MEMORANDUM – ADDENDUM NO. 2

To: Interested Vendors
From: Cindy Clack
Date: 11/10/2025
Re: RFB2026-08 Rebid Northwest Elevated Water Storage Tank -- Addendum No 2 (Total of 3 pages)

- Phoenix 750M Toro-Spherical-XX-01 Submittal (1 Page)

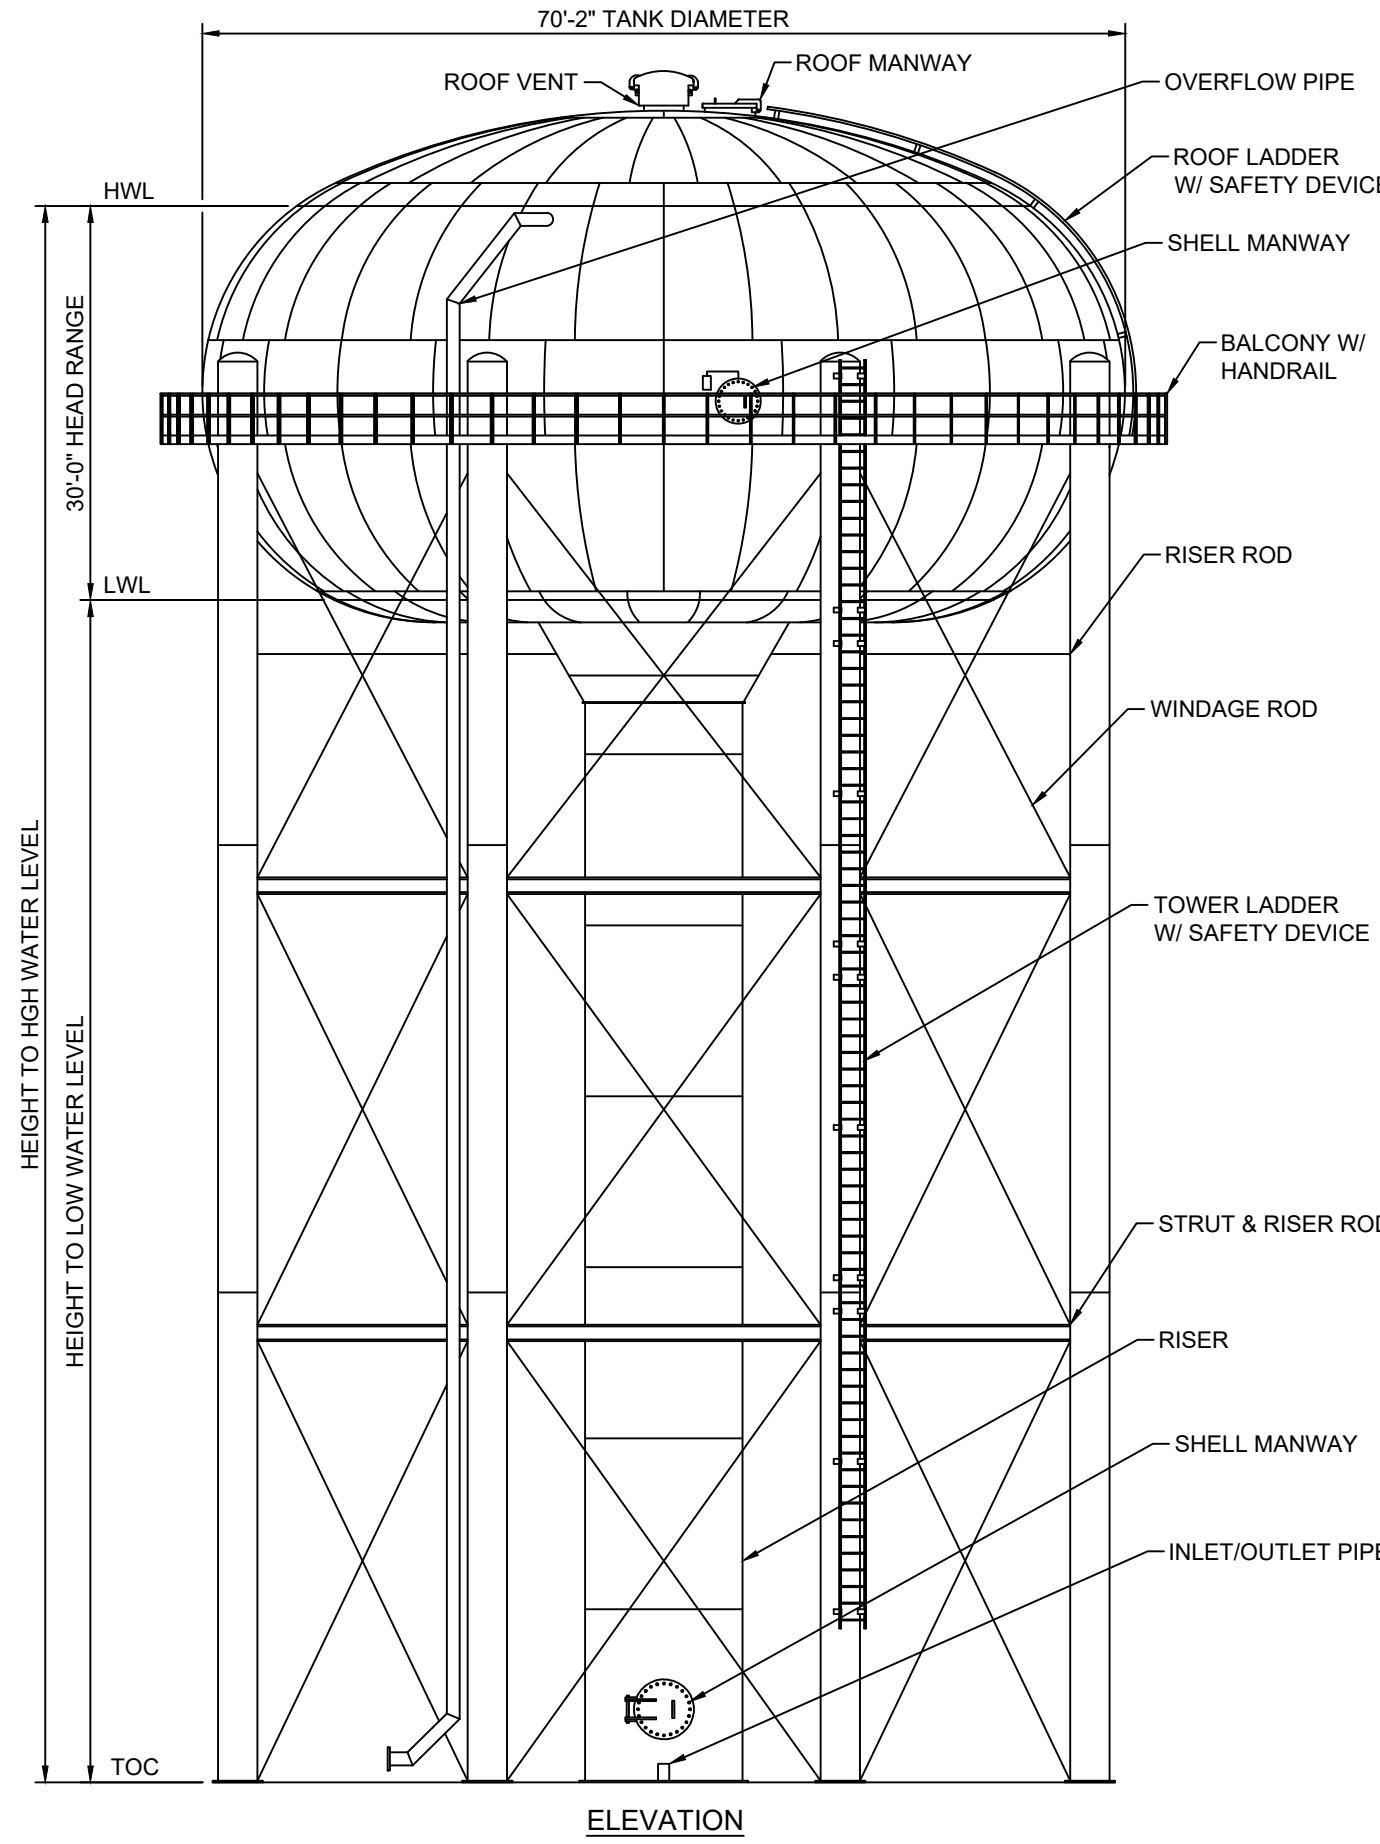
Q8. *Our TS design this size has a diameter of 70.17 ft and head range of 30 ft. Plans are showing 65 ft diameter and specs show a head range of 34 ft (+/-2.5 ft). Each Tank Manufacturer has their own standard tank geometry for each style... This varies only slightly, please let us know if our standard geometry is okay or if it needs to be specifically what is indicated in the plans/specs.*
A8. Any variation from the plans/specs shall be submitted to the Engineer for review and County approval. Submitted 750M Toro-Spherical-XX-01 is approved.
